Drawing Name : HELI UTILITY BASKET LH/RH 350/355
Part Number : D350607043
Drawing Number : D350-607 REV F P7-9
Project Number : N/A
Drawing Revision : F
Material : *N/A*
Due Date : 6/29/2007 Qty: 1 Um: Each

DESIGN <i>CP</i>	DRAWN BY <i>CP</i>	DART AEROSPACE LTD HAWKESBURY, ONTARIO, CANADA	
CHECKED <i>[Signature]</i>	APPROVED <i>[Signature]</i>	DRAWING NO. DSI 9318	REV. A SHEET 1 OF 1
DATE 06.01.06		TITLE WASHER ADDITION	SCALE NTS
A	06.01.06	NEW ISSUE

DART SERVICE INSTRUCTION

TO AMEND INSTALLATION INSTRUCTIONS D350-607 REV. F

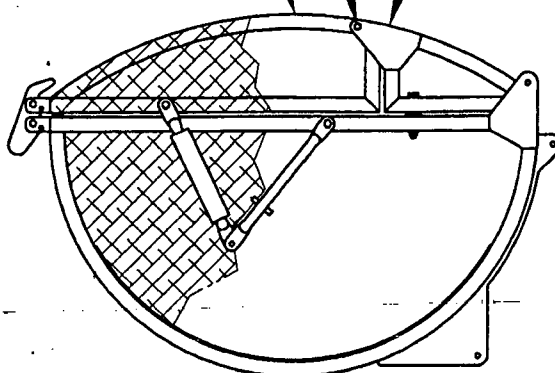
To reduce the possibility of damaging the finish, a **NAS1515H4** washer (2 places) has been added between the hinge plate and basket frame on the **D350-607-043/-047 Heli-Utility-Basket**.

The corrected bolt stackup from Figure 5 of installation instructions D350-607 Rev. F is given below:

AN4-13A BOLT (1)
AN960JD416 WASHER (1)
HINGE PLATE (REF)
NAS1515H4 WASHER (1)
BASKET FRAME (REF)
AN960JD416 WASHER (1)
MS21042L4 NUT (1)
(2 PLACES)
